Errata to
Load Calculation Applications Manual (2009)
July 20, 2009

Errata to
Load Calculation Applications Manual
September 2, 2009

Errata to
Load Calculation Applications Manual, I-P Edition
June 8, 2010

Errata to
Load Calculation Applications Manual (I-P and SI Editions)
May 17, 2011

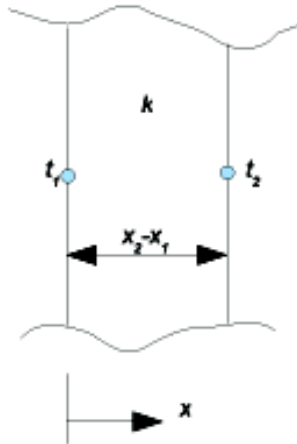
Page 6: Figure 2.1 is difficult to read. Please refer to this:

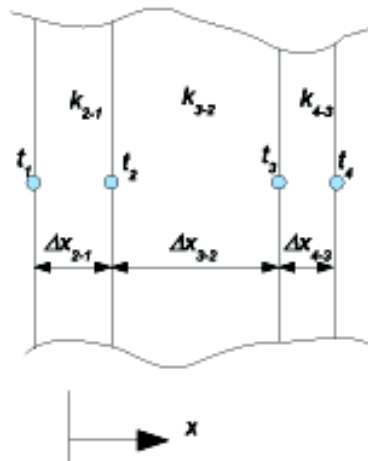
Page 7: Figure 2.2 is difficult to read. Please refer to this:

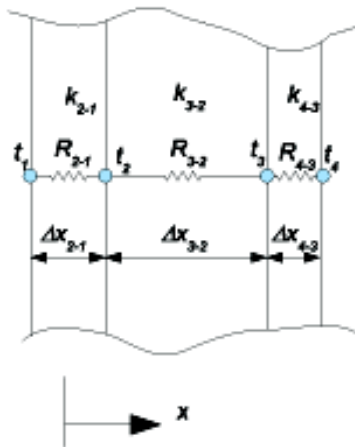
Page 8: Figure 2.3 is difficult to read. Please refer to this:

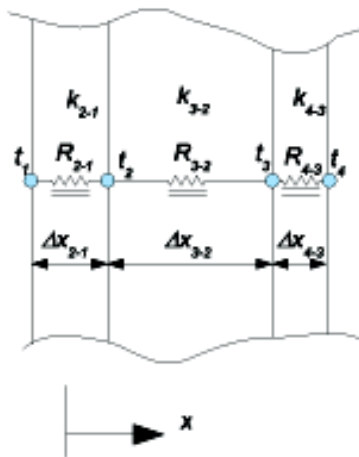
Page 11: Figure 2.4 is difficult to read. Please refer to this:

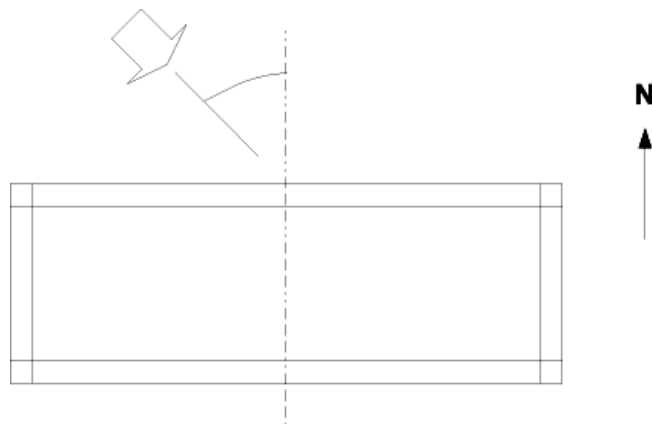
Page 89: Figure 5.7 is difficult to read. Please refer to this:

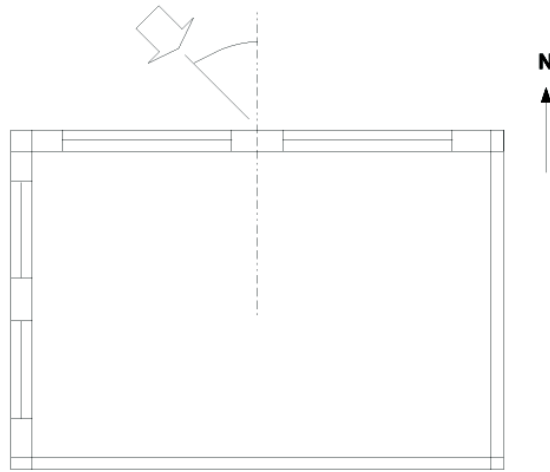
Page 102: Figure 5.17 is difficult to read. Please refer to this:

Figure 9.2 Psychrometric processes for Example 9.1.

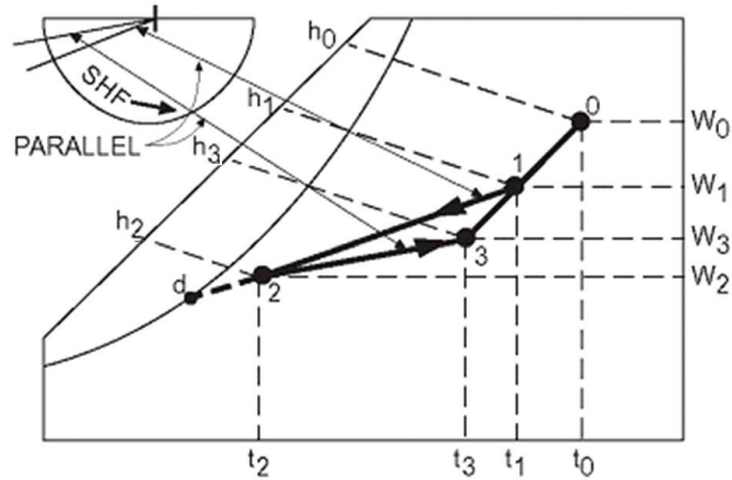
8	181	The first sentence should refer to Table 6.2, not Table 6.3.
8	186	The first sentence in Section 8.3.4 should refer to Equation 7.5, not 7.4.
8	190	Table 8.21 is missing the "Hour" column on the left hand side of the table. See pg. 4 of this errata list for the corrected table.
9	202	Mislabeled "h ₂ " and "h ₃ " on Figure 9.2. See pg. 5 of this errata list for the corrected figure.
9	203	In the first full paragraph on the page, the sentence should read, "The data for specific volume v from a proper psychrometric chart or from Table A.2 should be used for elevations above 2500 ft," not Table 9.2.
9	204	In Equation 9.3, it should be " m_{a1} ," not " m_{ai} ."
9	204	Toward the bottom of the page, the sentence should read, "Alternately, the sensible load on the coil could be computed from Equation 9.1a," not Equation 9.16.
9	207	In Example 9.3 in the solution equation, it should read "cfm _m = 300(5)..." not "cfm _m + (5)..."
